**Recall Service Bulletin
RSB24-120-004**

APPLIES TO: This service bulletin applies to certain model year 2023-2024 FC-94 model emergency response chassis cabs built between April 2023 and March 2024.

CONDITION: Certain driver front seats may have been installed in the cab with incorrect fasteners.

Figure 3.1

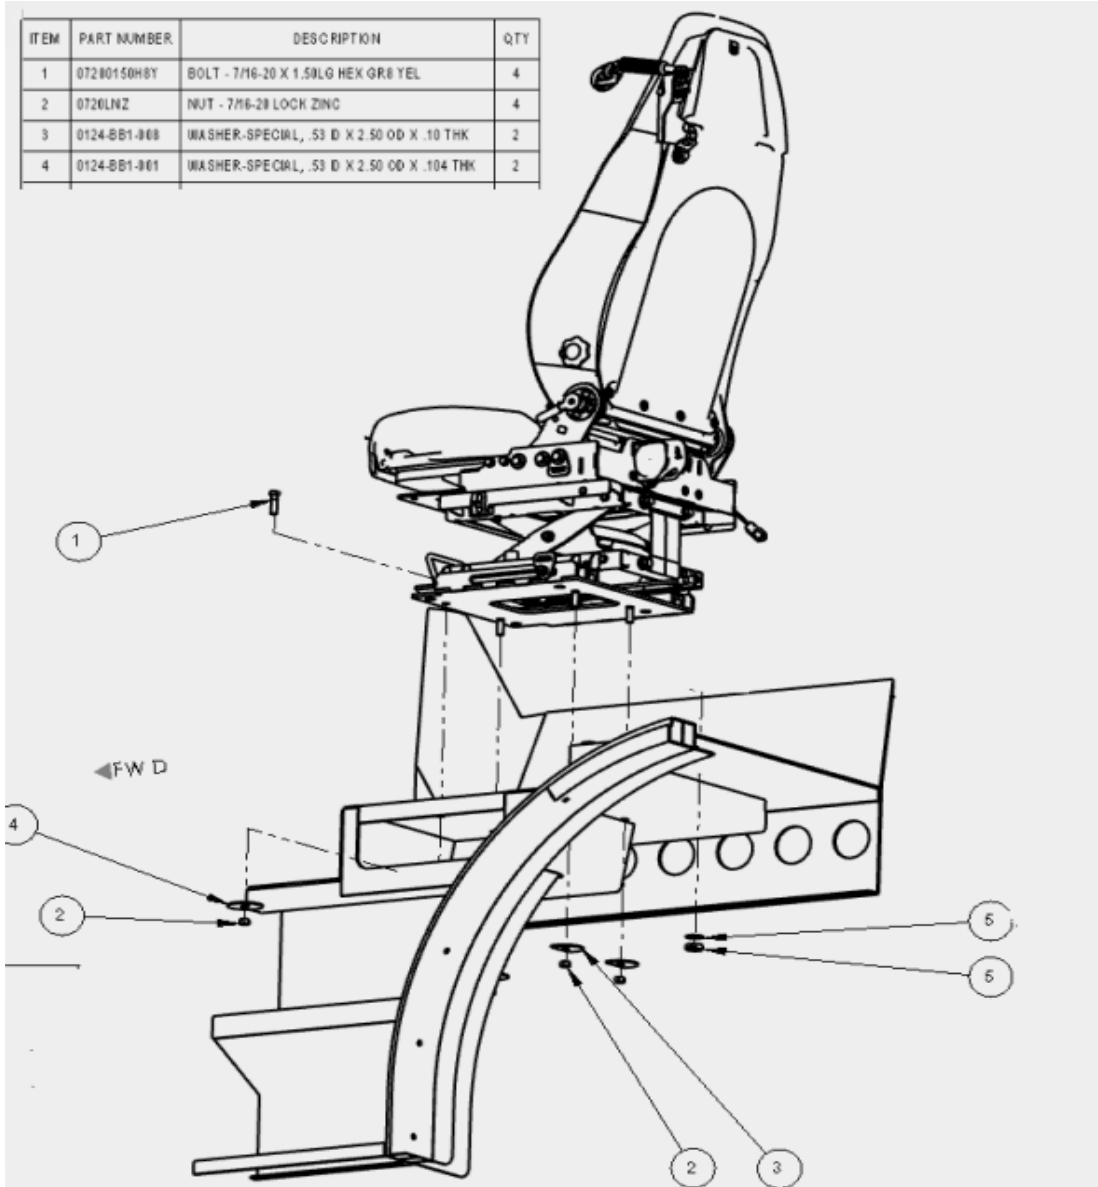
- 1) Locate driver seat mounting bolts. *See Figure 3.1*
- 2) Inspect bolts and determine the diameter of each bolt.
- 3) If they are 3/8-inch diameter, bolts will require replacement with 7/16 diameter hardware.
- 4) If bolts are already 7/16 inch diameter, then no further action is necessary.
- 5) If bolts are 3/8 inch, replace with 7/16 inch hardware as shown in figure 3.1.
- 6) Torque nuts to 55 ft lbs.

Figure 4.1

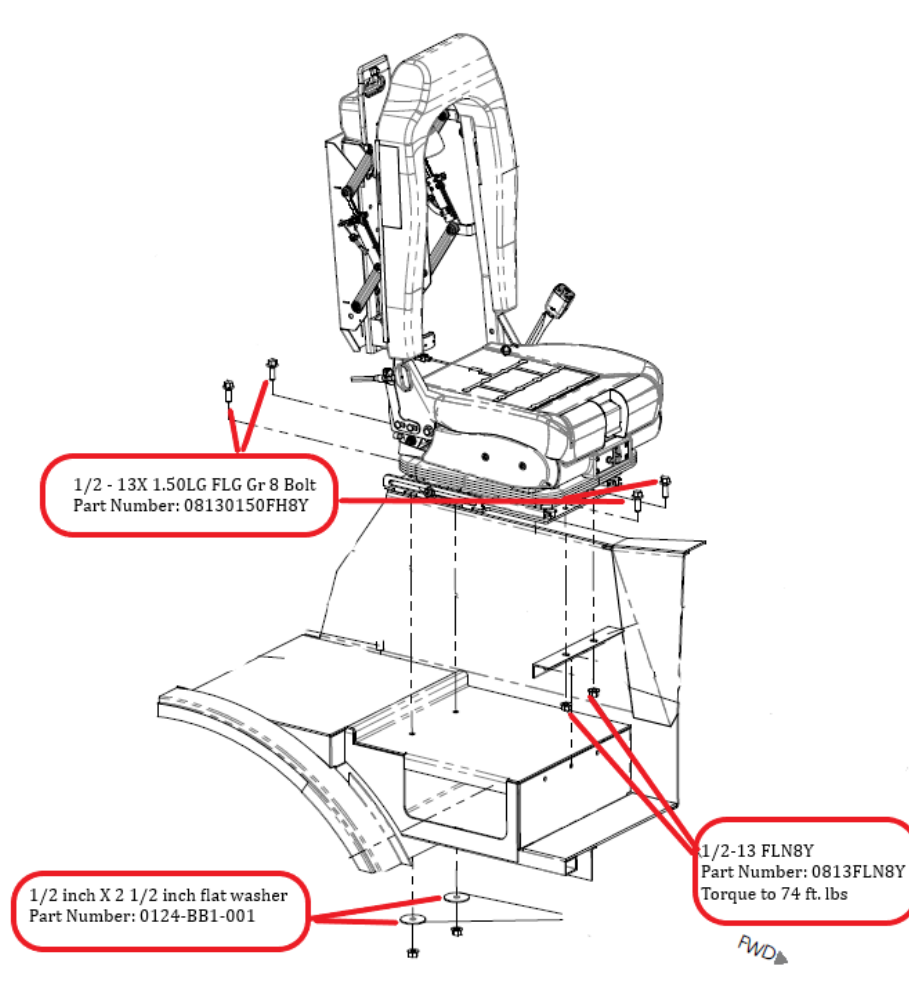
- 1) Locate officer seat mounting bolts. *See Figure 4.1*
- 2) Inspect bolts and determine the diameter of each bolt.
- 3) If bolts are already 1/2 inch diameter, then no further action is necessary.
- 4) If bolts are 3/8 inch, replace with 1/2 inch hardware as shown in figure 4.1.
- 5) Torque nuts to 74 lb-ft.
